Questions and Answers #1 for Solicitation #NNC11359052R – Stitching and Weaving of Ceramic Materials

Referencing Section C (The Statement of Work):

8HS 1.5D

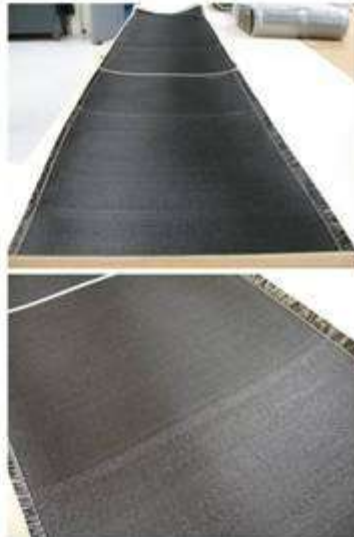
- 1. “Does NASA have specific weave designs in mind for the 8HS (1.5D), 8HS (Double) and 8HS (2.5D) constructions in Table 1? Can the design(s) be provided to us to ensure the accuracy of our quote?”

NASA DOES HAVE SPECIFIC WEAVE DESIGNS IN MIND:

8	X	X		X	X	X		X
7		X		X		X		X
6		X	X	X		X	X	X
5			X	X				X
4	X		X	X	X			X
3	X		X		X			X
2	X	X	X		X	X	X	
1	X	X			X	X		
	1	2	3	4	5	6	7	8

In the 8HS 1.5, each yarn floats over 5 others
